**ATTACHMENT A**  
**BLM COMMENT RESPONSES**  
**WITH EXTENDED NARRATIVES**  
**MARCH 31, 2017**

**BLM GENERAL 5**

**Figure 5-42  
Virgin River at Littlefield, Daily Flows**

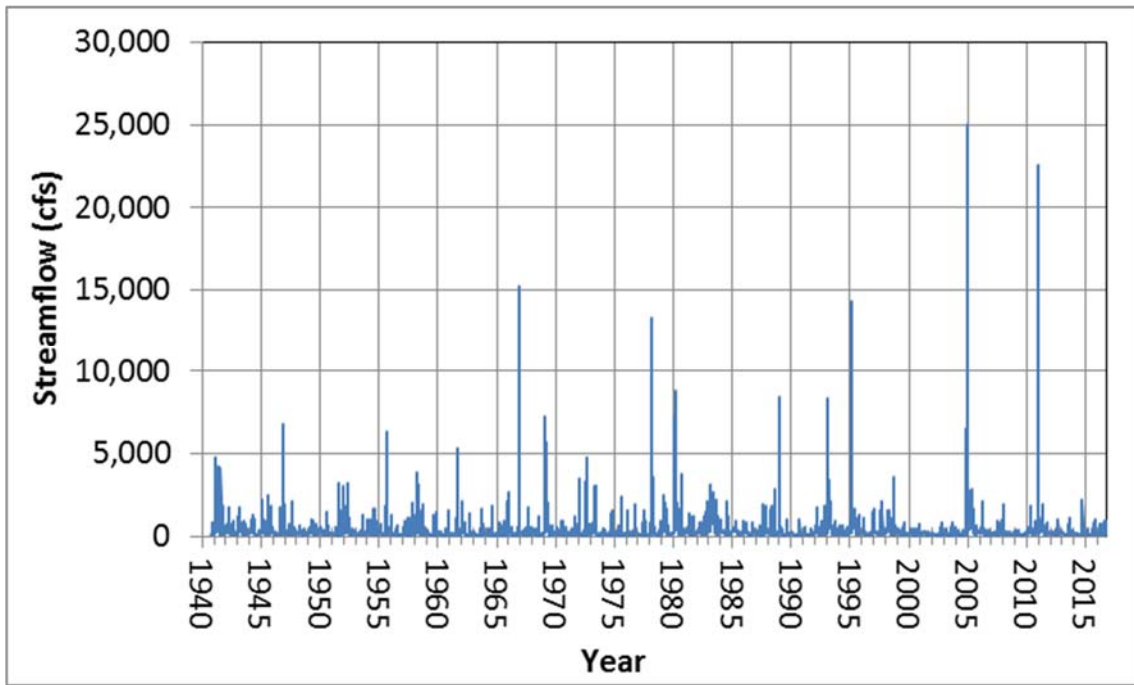
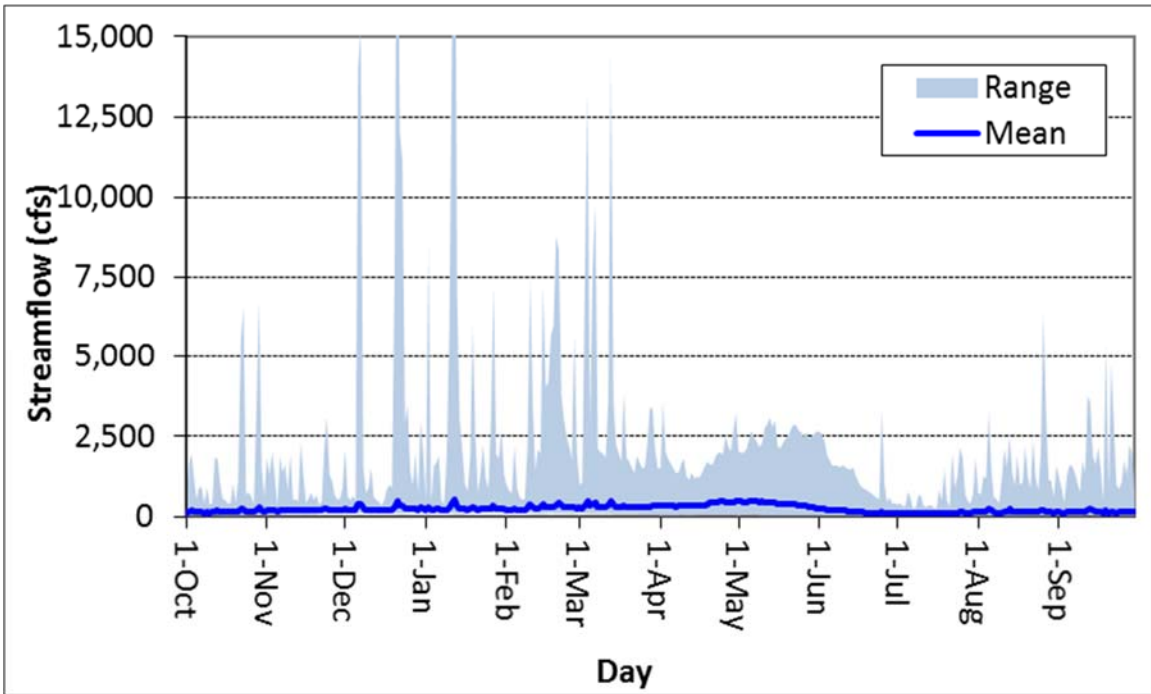
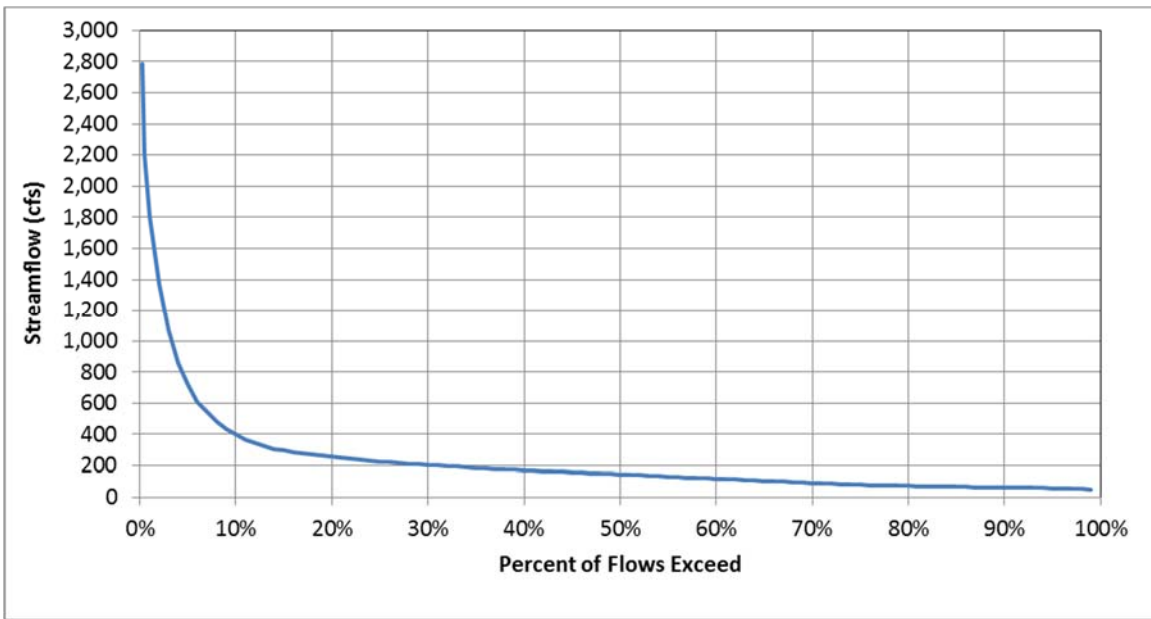
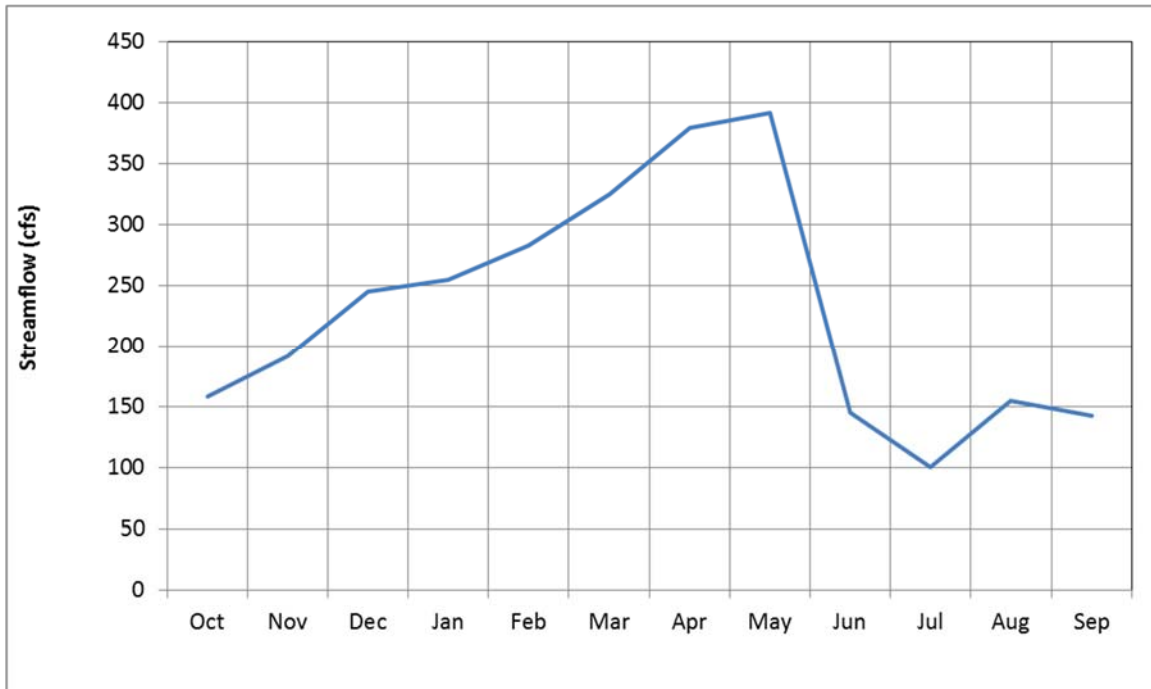
**BLM 601**

The Final License Application filed with FERC shows the figure in BLM Comment No. 601 as Figure 5-42. The updated Figure 5-42 displaying Mean Daily Flows for the Virgin River at Littlefield for the period 1940 through September 30, 2016 is shown below. Figure 5-43 in the Final License Application changed as a result of the updated data shown in Figure 5-42. The updated Figure 5-43 is shown below.

Figure 5-44 in the Final License Application changed as a result of the updated data shown in Figure 5-42. The updated Figure 5-44 displaying the flow exceedance curve for the Virgin River at Littlefield for the period 1940 through 2016 is shown below. The text referencing the reader to Figure 5-44 is changed to read as follows: **Figure 5-44 shows the flow exceedance curve. The 90 percent exceedance value is 62 cfs while the 10 percent exceedance value is 398 cfs. The median flow is 145 cfs.**

Figure 5-45 in the Final License Application also changed as a result of the updated data shown in Figure 5-42. The text referencing the reader to Figure 5-45 is changed to read as follows: **Figure 5-45 shows monthly average flows for the Virgin River at Littlefield, Utah gage for the period of 1940 through 2016. Similar to upstream locations, peak flows occur in late spring with low flows in the summer.** The updated Figure 5-45 showing the Monthly Mean Flows for the Virgin River at Littlefield for the period 1940 through 2016 is shown below.

**Figure 5-46**  
**Virgin River at Littlefield, Annual Mean Flows**

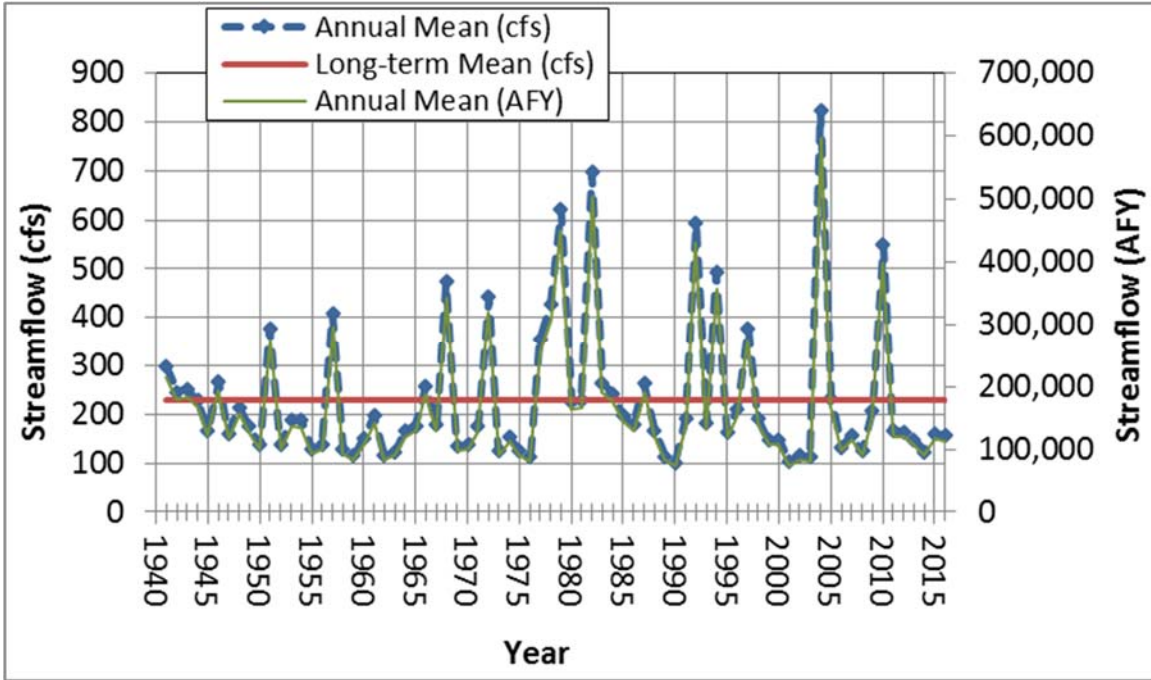
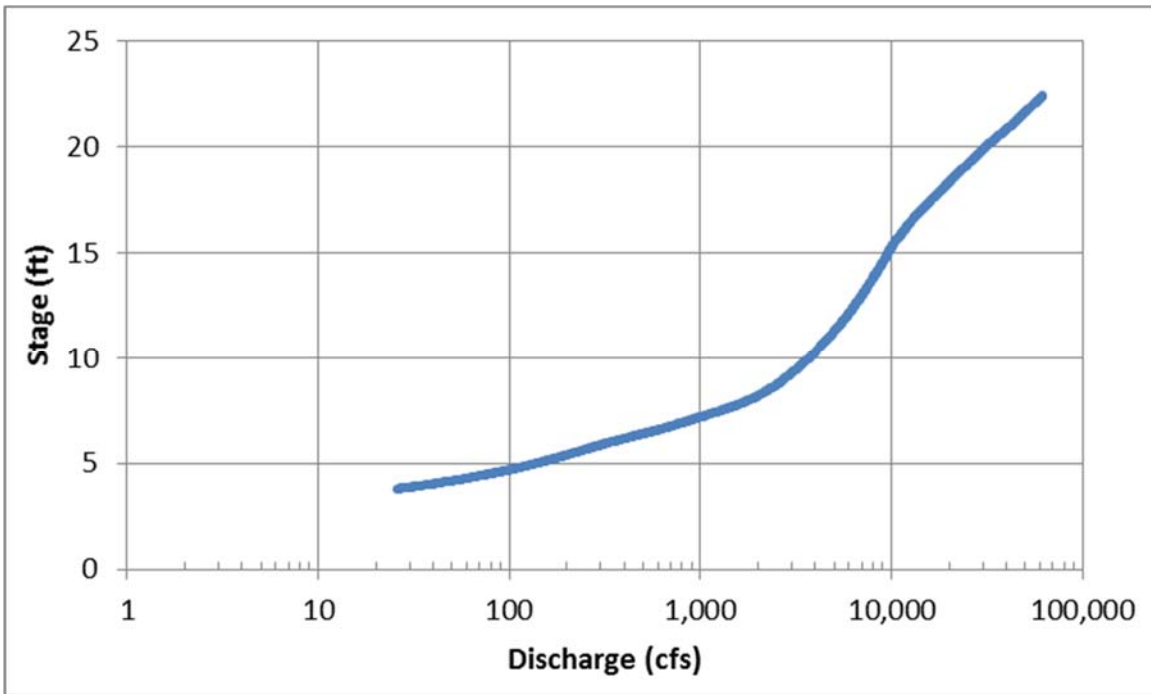
### **BLM 603**

The Final License Application filed with FERC shows the figure in BLM Comment No. 603 as Figure 5-46. The text referencing the reader to Figure 5-46 is changed to read as follows: **The long term annual mean streamflow is 230 cfs.** The updated Figure 5-46 displaying Virgin River at Littlefield, Annual Mean Flows 1940 through 2016 is shown below. Figure 5-47 in the Final License Application is changed as a result of the updated data shown in Figure 5-46. The updated Figure 5-47 is shown below.

**Figure 5-48  
Santa Clara River at St. George Daily Flows**

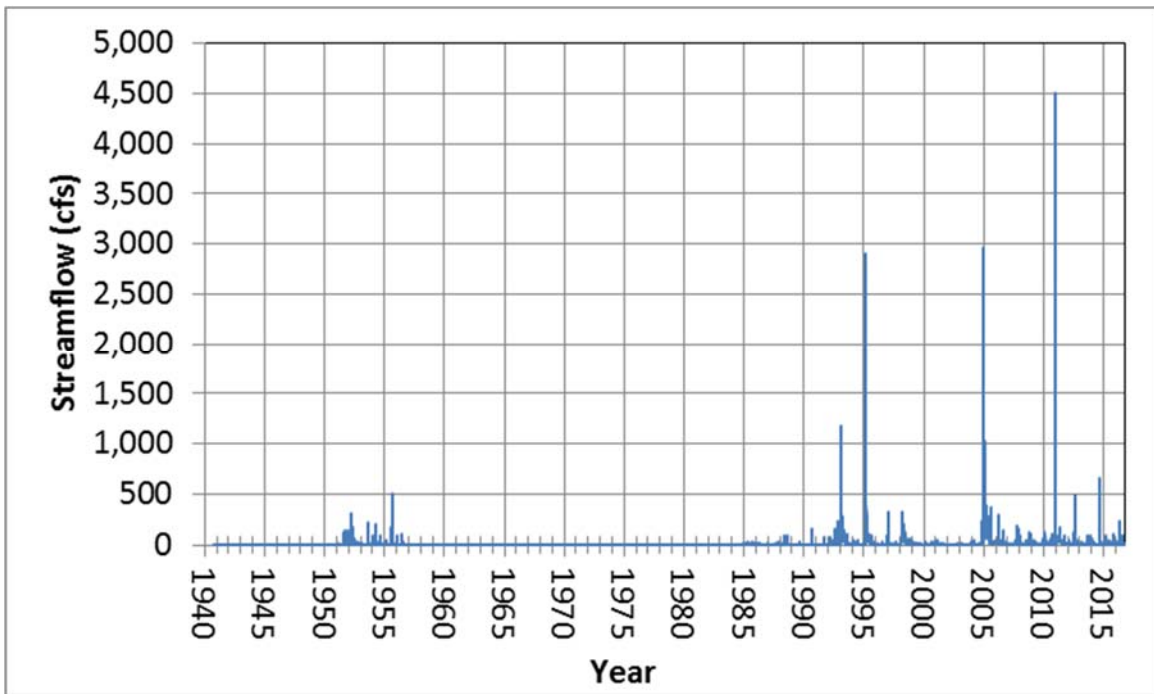
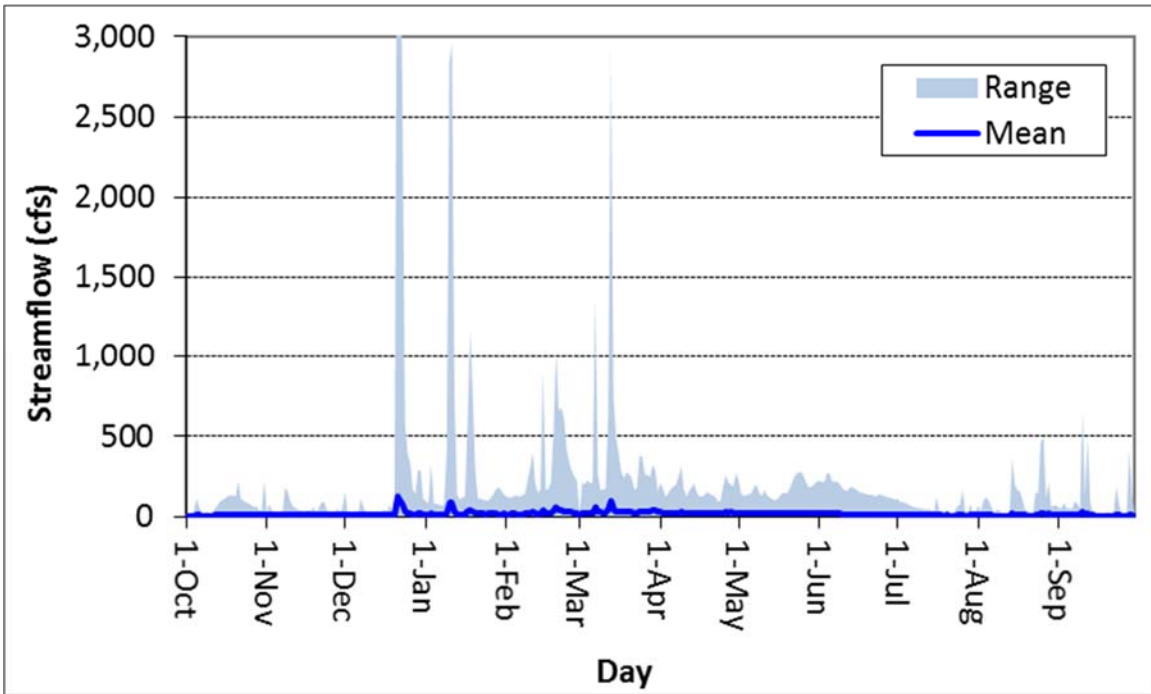
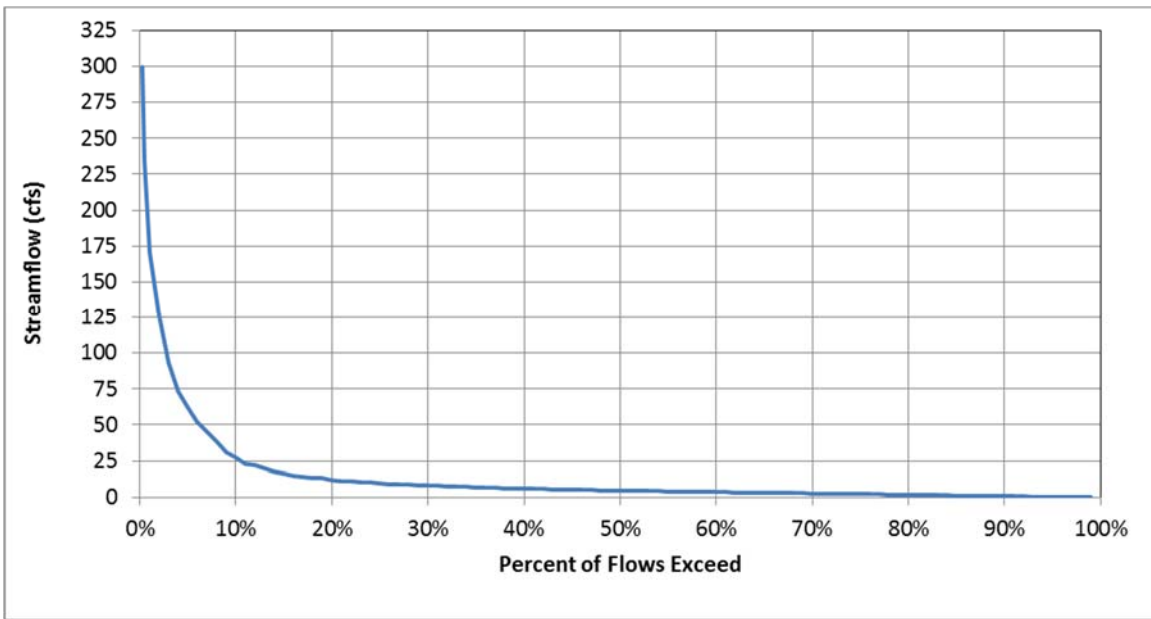
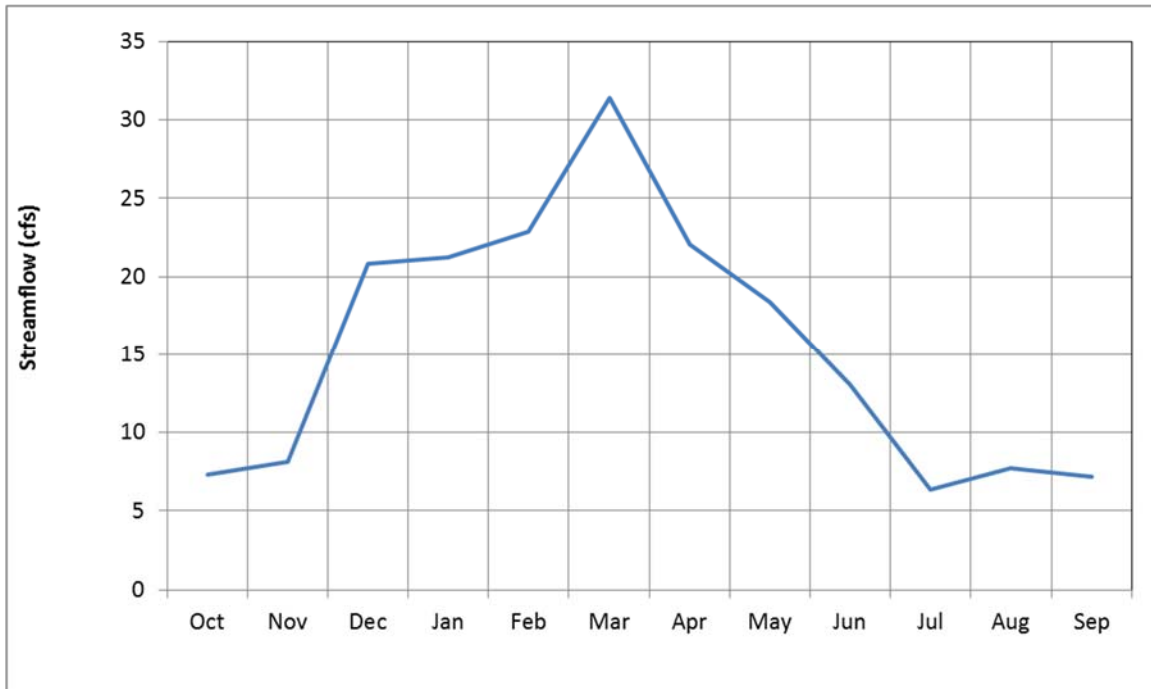
**BLM 605**

The Final License Application filed with FERC shows the figure in BLM Comment No. 605 as Figure 5-48. The updated Figure 5-48 displaying Mean Daily Flows for the Santa Clara River at St. George for the period 1940 through September 30, 2016 is shown below. Figure 5-49 in the Final License Application is changed as a result of the updated data shown in Figure 5-48. The updated Figure 5-49 is shown below.

Figure 5-50 in the Final License Application is changed as a result of the updated data shown in Figure 5-48. The updated Figure 5-50 displaying the flow exceedance curve for Virgin River at Littlefield for the period 1940 through 2016 is shown below. The text referencing the reader to Figure 5-50 is revised to read as follows: **Figure 5-50 shows the flow exceedance curve. The 90 percent exceedance value is 1 cfs while the 10 percent exceedance value is 27 cfs. The median flow is 5 cfs.**

Figure 5-51 in the Final License Application also changed as a result of the updated data shown in Figure 5-48. The text referencing the reader to Figure 5-51 is changed to read as follows: **Figure 5-51 shows monthly mean flows for the Santa Clara River at St. George, Utah gage for the period of 1940 through 2016. Peak flows occur in the spring with low flows occurring in the late summer into fall.** The updated Figure 5-51 displaying Monthly Mean Flows for the Santa Clara River at St. George for the period 1940 through 2016 is shown below.

**Figure 5-52**  
**Santa Clara River at St. George Annual Mean Flows**

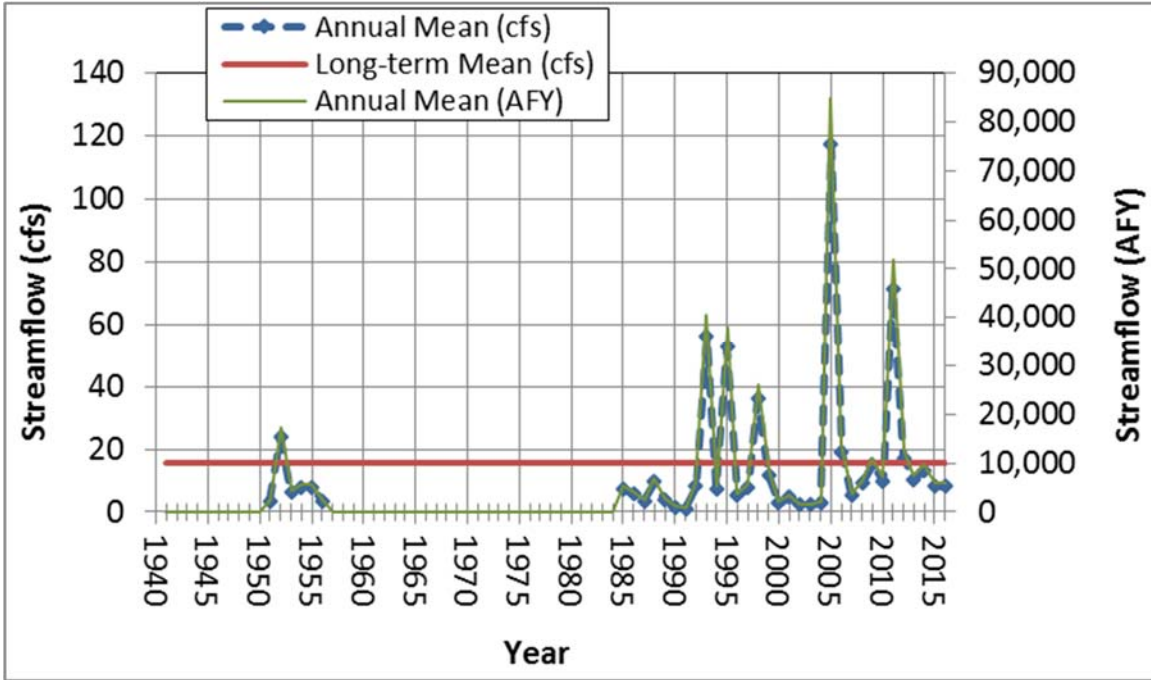
### **BLM 607**

The Final License Application filed with FERC shows the figure in BLM Comment No. 607 as Figure 5-52. The text referencing the reader to Figure 5-52 is changed to read as follows: **The long term annual mean streamflow is 16 cfs.** The updated Figure 5-52 showing Santa Clara River at St. George, Annual Mean Flows through 2016 is shown below. The last data point on the graph represents the annual mean flow for the period January 1, 2016 through December 31, 2016. Figure 5-53 in the Final License Application is changed as a result of the updated data shown in Figure 5-52. The updated Figure 5-53 is shown below.
